Agenda
Huntington Planning Commission
Monday, January 6, 2025 – 5:30pm

PC 24-07

Issue: A proposal to develop a public utility installation to include a replacement water tower and access road on a property that is approximately 0.23 acres. The property is located at 111 Kings Hwy. and zoned R-1 Single Family Residential District. The site plan must be reviewed according to the development requirements due to the hillside site being an average of more than fifteen (15) percent grade. In addition, a request for waiver from the requirements of 1391.05 to create a slope exceeding a vertical rise of one foot for each two and one-half feet of horizontal distance will be considered.

ROLAND PARK WATER STORAGE TANK IMPROVEMENTS

EROSION & SEDIMENT CONTROL PLAN

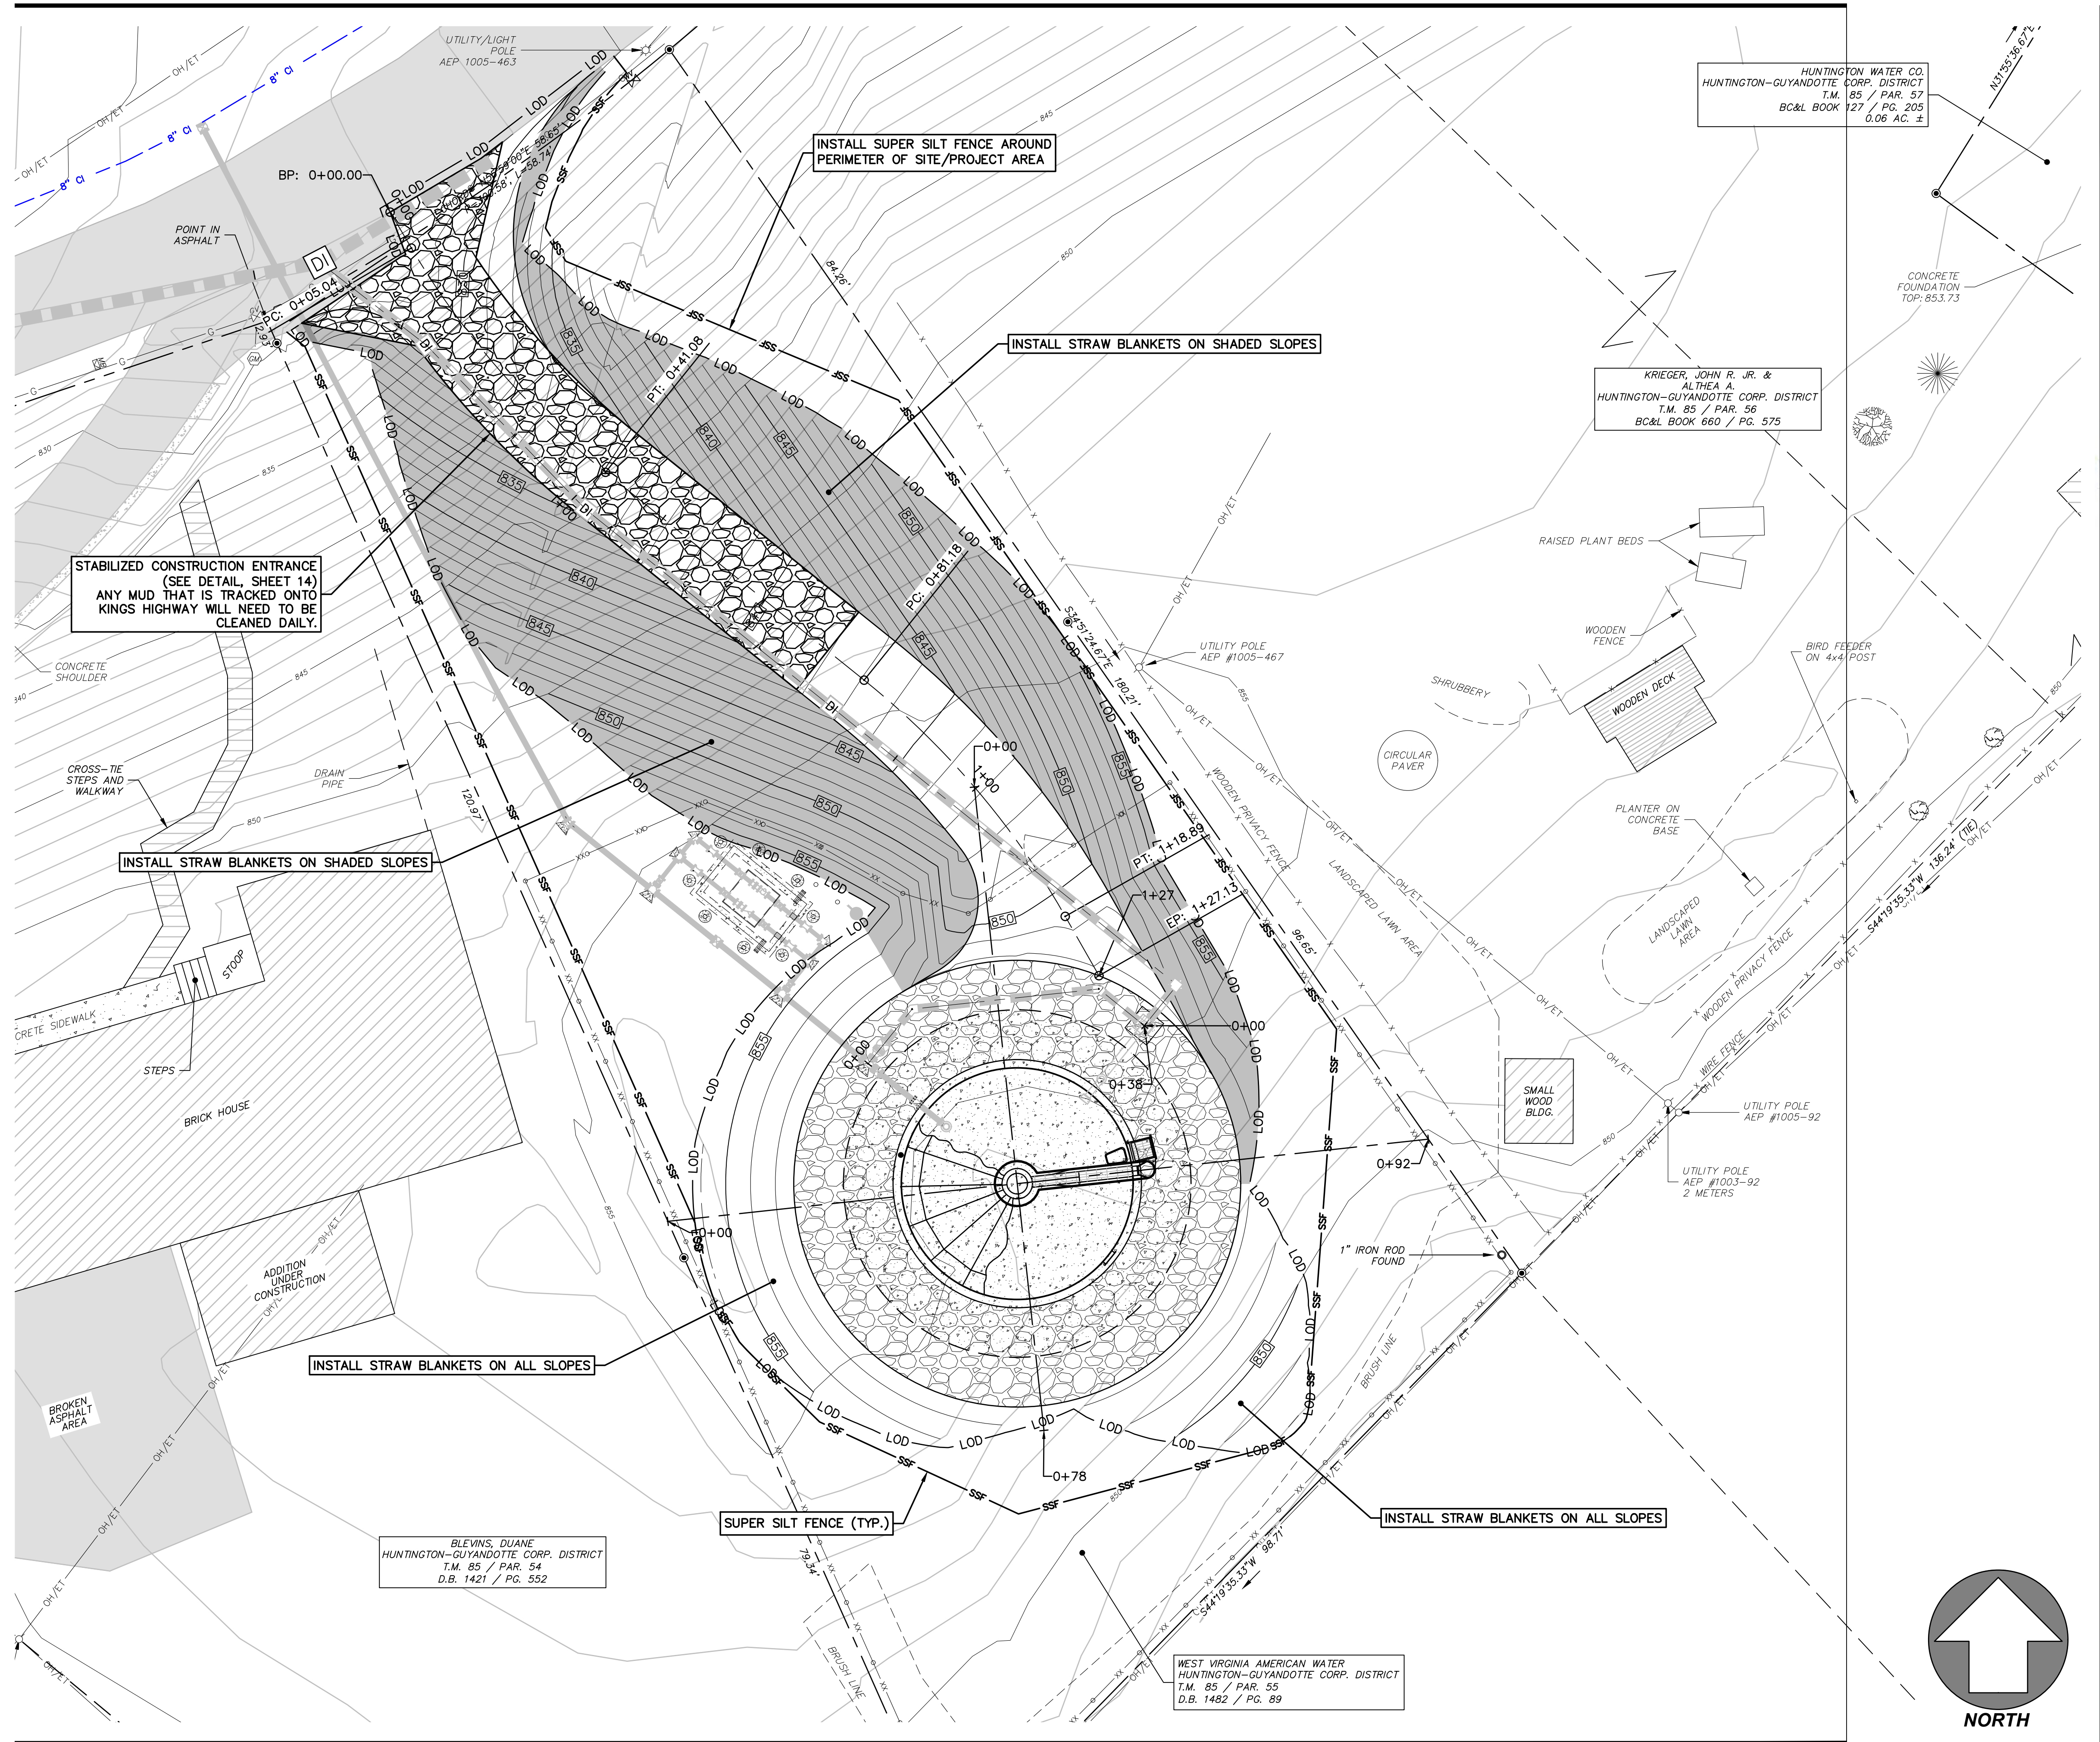
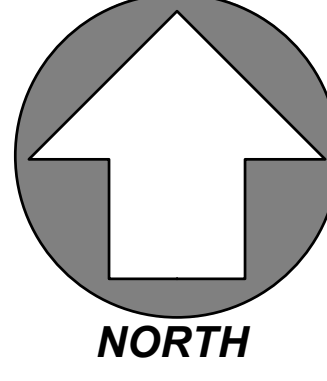
Huntington Stormwater Utility: Does not object to this project. WVAW submitted a sediment and erosion control plan that was found satisfactory.

STABILIZED CONSTRUCTION ENTRANCE
(SEE DETAIL, SHEET 14)
ANY MUD THAT IS TRACKED ONTO
KINGS HIGHWAY WILL NEED TO BE
CLEANED DAILY.

INSTALL SUPER SILT FENCE AROUND
PERIMETER OF SITE/PROJECT AREA

INSTALL STRAW BLANKETS ON ALL SLOPES

Roland Park Tank Access Road - Sta. 0+75 LT CL

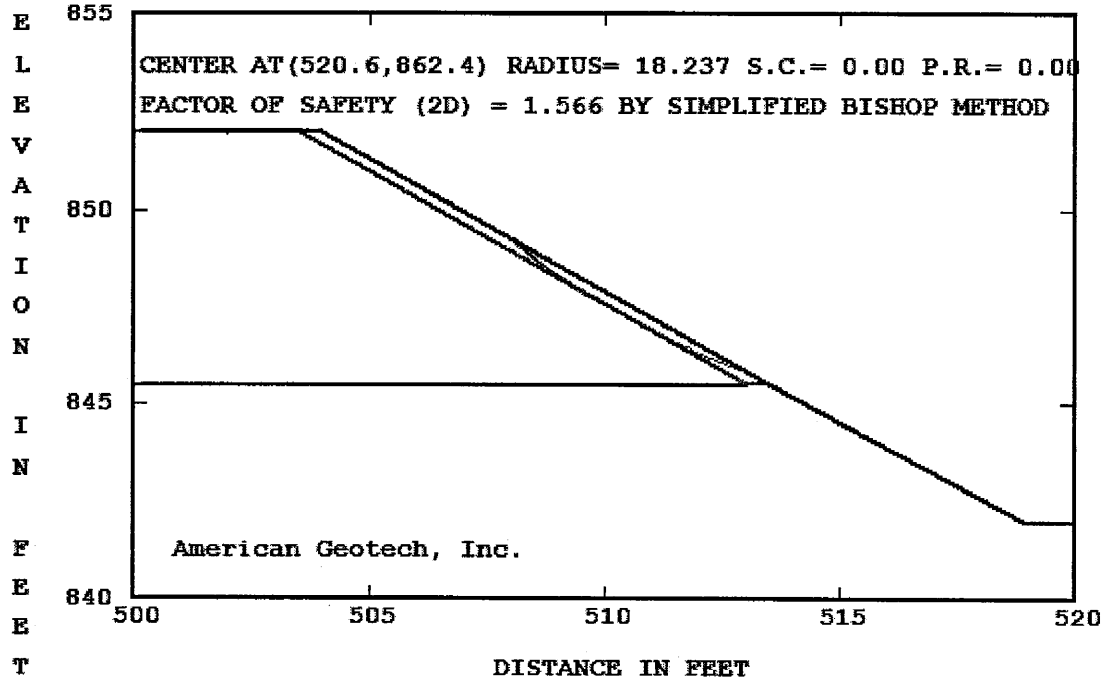
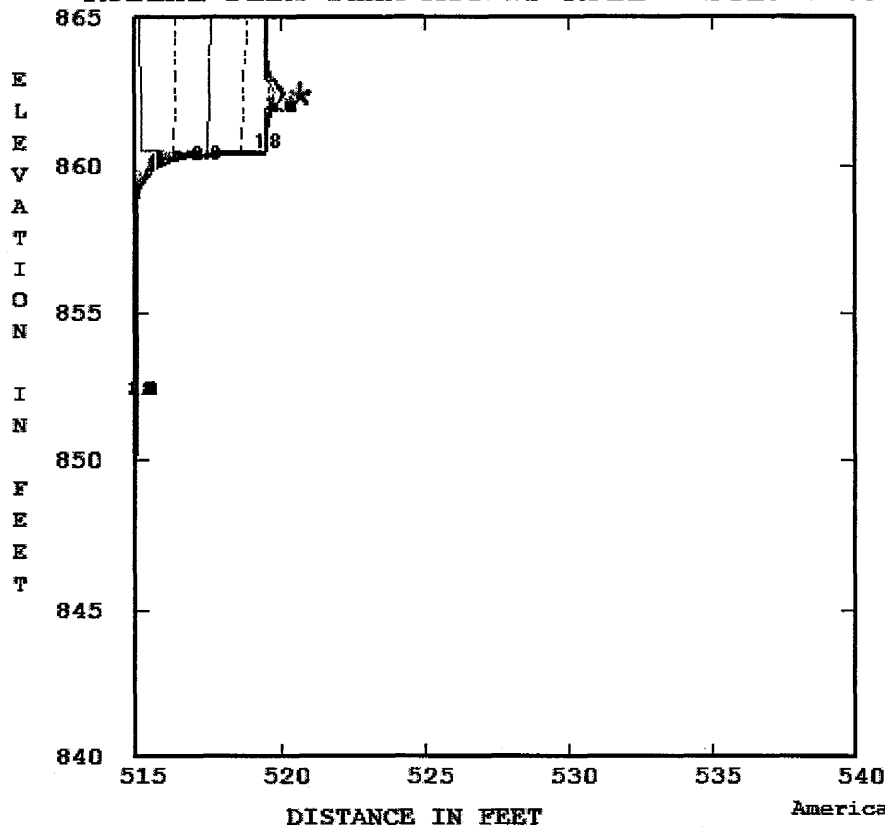
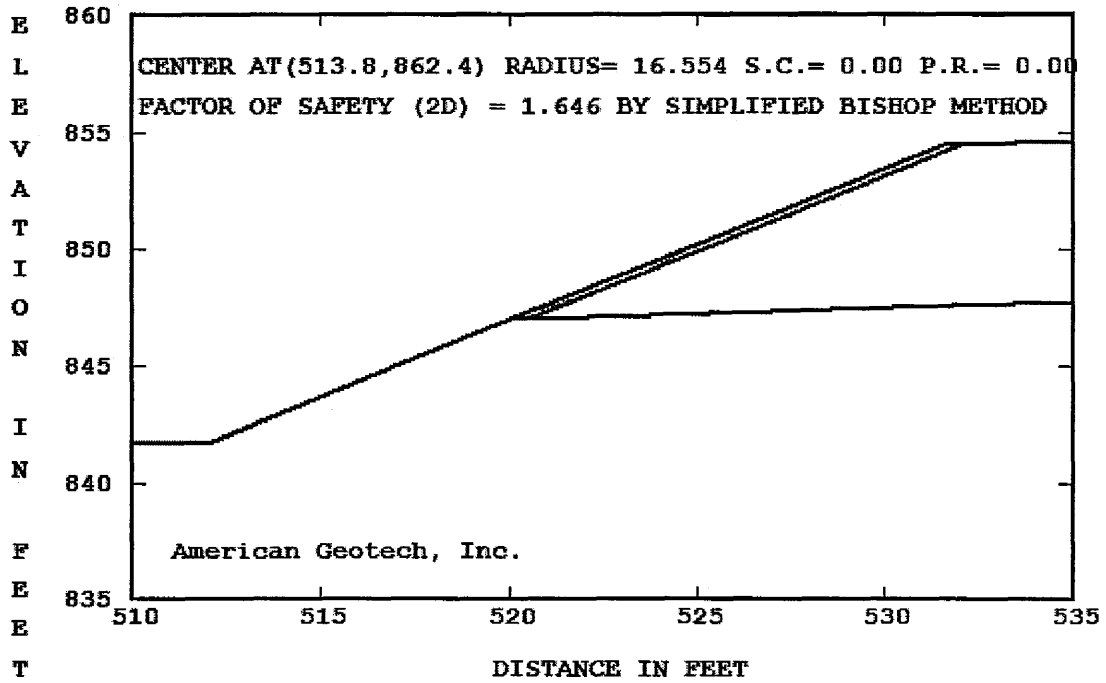
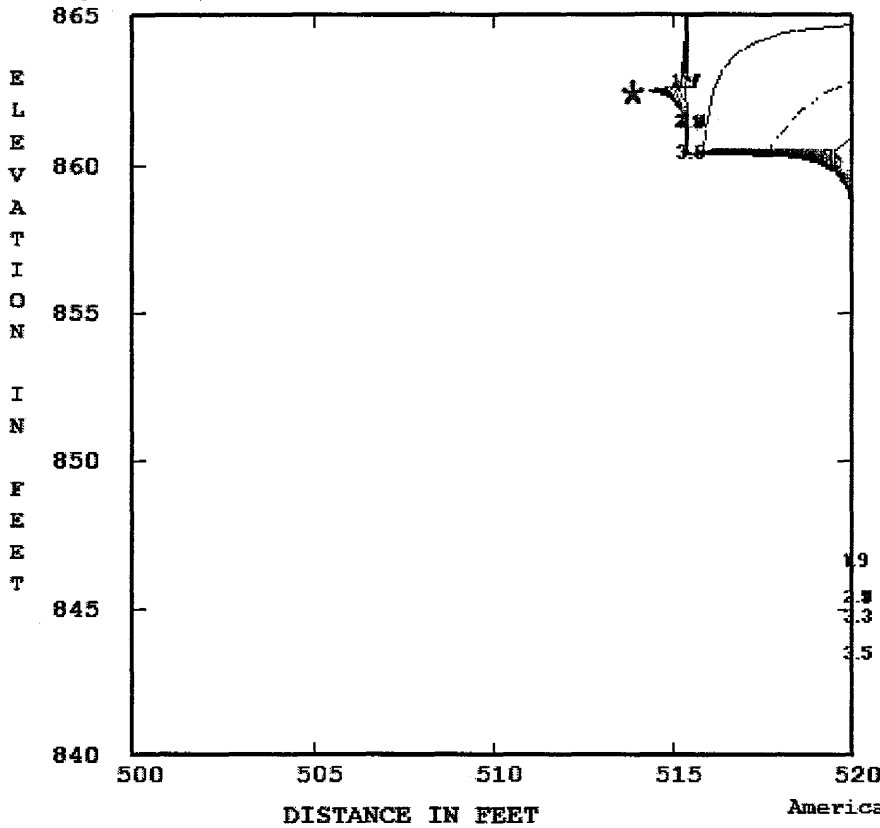
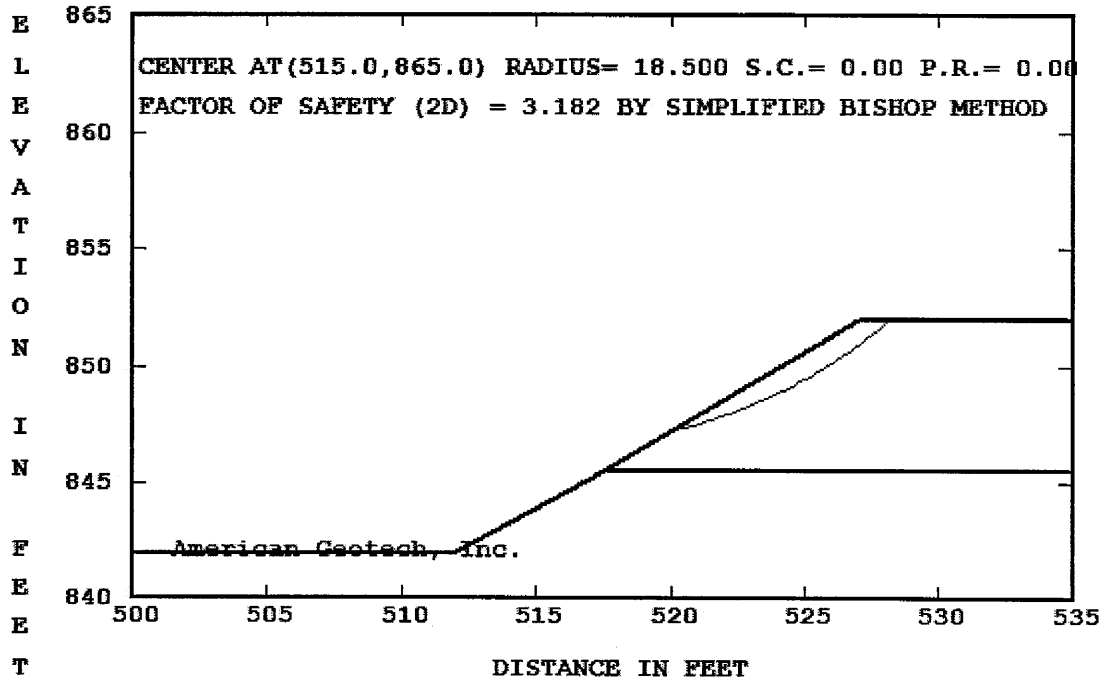
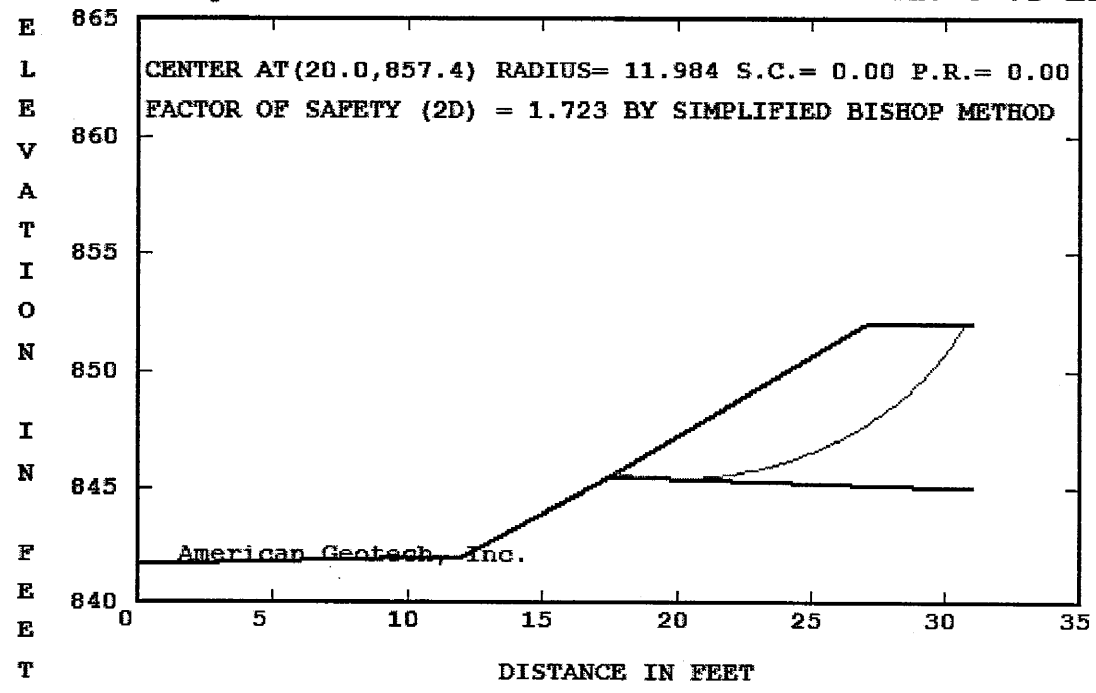
AGI has completed slope stability analysis on two (2) critical cut slope sections. To address review comments submitted by Terradon Corporation, additional analysis was completed to show shallow failure slices on the critical section, as well as confining the soil portion of the cut slopes with a 6 inch thick layer of rip rap. We selected the critical cut cross-sections for analysis where the proposed benching would cut deepest into the existing ground. The locations of the critical design sections are shown on the Grading Plan prepared by Ghosh Engineers and dated 12/5/2023. Subsurface information obtained from the 2022 field exploration and laboratory test programs were used to develop a soil/rock model and perform an evaluation of the slope stability. AGI has also assumed that the bedrock is relatively horizontally bedded. No inclined bedding or unfavorable dipping of the rock formation is present. Slope stability was analyzed using effective stress and total stress methods, which use long-term, post construction conditions. Effective stress analysis assumes that the post construction slopes will be maintained in drained conditions by providing drainage ditches and rip rap on the cut slopes. In the Total Stress analysis, we assumed that the pore pressure is not allowed to dissipate and stresses are carried by pore pressure. This represents maximum stresses that occur immediately after construction when the slopes are most vulnerable.

The new 127 foot long access road alignment traverses the sloping hillside from King's Highway up to the tank pad. Final ground elevations for the access road range from 829 feet, at the beginning on King's Highway, up to 852 feet at the new tank pad. The access road will be constructed as a "V" notched cut running generally perpendicular to the existing slope to produce a 12 foot wide roadway. The provided grading plan indicates that cut slopes are designed at 1.5H:1V with maximum cut slope heights of 13 feet.

Identification of unstable areas is essential to the successful construction and longevity of the proposed slopes. Soft, loose unsuitable soils should be removed prior to final slope grading. If the area continues to display an unsatisfactory surface, the geotechnical engineer should be consulted to provide additional methods to stabilize the surface or depth to anticipated competent material. Controlling subsurface water in the embankments is the key for the successful performance of the cut slopes.
